PROJECT NAME: ESTATES AT PRAIRIE TRAIL PLAT 3  
DESCRIPTION: ANKENY, IOWA  
GRADING PLAN

PROJECT NO.: 14055  
DATE: 06/23/14  
DRAWN BY: TJH/ADS  
CHECKED BY: GMP  
SCALE: AS NOTED  
SHEET TITLE: R.01  
SHEET NO.: 13/14

ESTATES AT PRAIRIE TRAIL PLAT 1  
 ANKENY, IOWA  
 GRADING PLAN

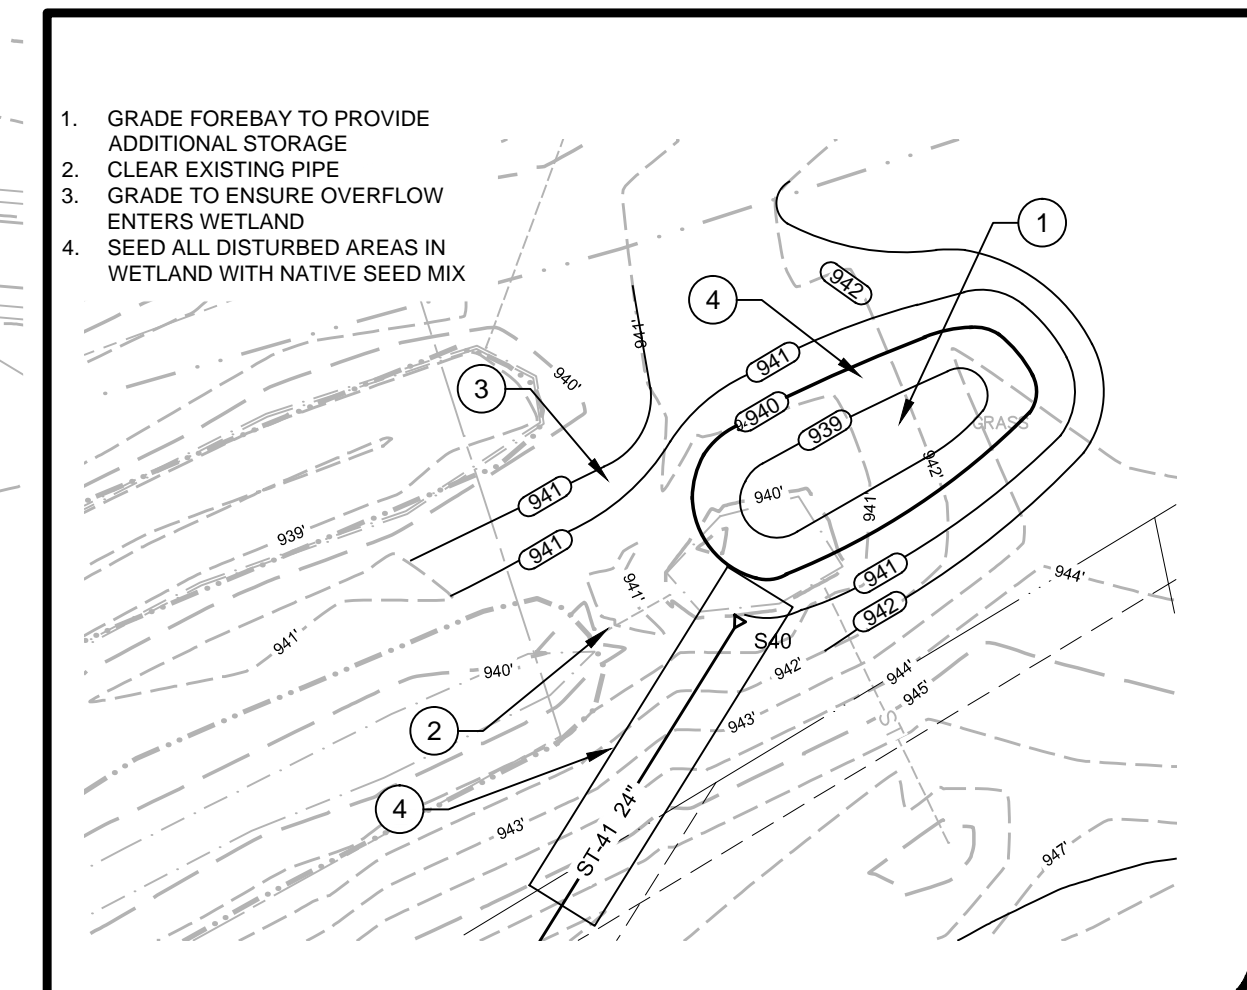
1. GRADE FOREBAY TO PROVIDE ADDITIONAL STORAGE
2. CLEAR EXISTING PIPE
3. GRADE TO ENSURE OVERFLOW ENTERS WETLAND
4. SEED ALL DISTURBED AREAS IN WETLAND WITH NATIVE SEED MIX
